Access Compliance Report

Public Rights-of-Way

(Curb Ramps)

Intersection ID: 11037	Main Street: SUMTER_AV	Cross Street: WESTBROOK_DR	Location:	N
ADA ID: C98AD9BD53F1	Ramp Type: PerpDiag	Initial Pass/Fail: Fail	Overall Compliance: No	Severity Score: 47.5
Codes/Mitigation Info/Possible Solution		Field Measurements/Component Compliance

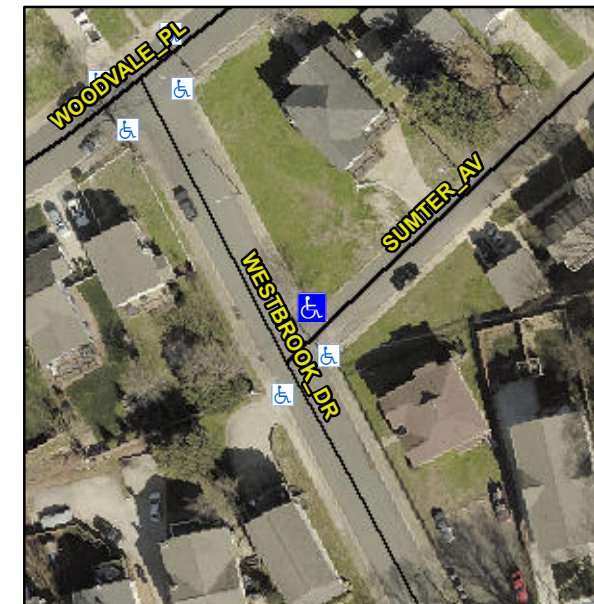
Not Found, R304.5.1, R304.2.2

Compliance	Description	Data	Compliance	Description	Data
N/A	Ramp Length (in)	56.0	No	Ramp Slope (%)	8.8
No	Ramp Width (in)	30.0	Yes	Ramp XSlope (%)	0.3
N/A	Flare Type LT	N/A	N/A	Flare Type RT	N/A
N/A	Flare Slope LT (%)	N/A	N/A	Flare Slope RT (%)	N/A
N/A	Flare Traversable LT?	N/A	N/A	Flare Traversable RT?	N/A
N/A	Landing Length (in)	N/A	N/A	DWS Provided?	N/A
N/A	Landing Width (in)	N/A	N/A	DWS Contrast?	N/A
N/A	Landing Slope (%)	N/A	N/A	DWS Length (in)	N/A
N/A	Landing X Slope (%)	N/A	N/A	DWS Full Width?	N/A
N/A	Landing Curb? (Y/N)	N/A	N/A	DWS Offset (in)	N/A
N/A	Shared Landing?	N/A			
N/A	Gutter Ponding?	N/A	N/A	Gutter Slope (%)	N/A
N/A	Gutter Lip Ht (in)	N/A	N/A	Gutter X Slope (%)	N/A
N/A	Painted X Walk1?	No	N/A	Painted X Walk2?	No
	X Walk 1 Direction	To W		X Walk 2 Direction	To S
N/A	X Walk 1 Width (in)	N/A	N/A	X Walk 2 Width (in)	N/A
	X Walk 1 Slope (%)	1.8		X Walk 2 Slope (%)	2.3
	X Walk 1 X Slope (%)	0.3		X Walk 2 X Slope (%)	1.8

Remove & Replace Curb Ramp With Two New Directional Ramps or Equivalent.
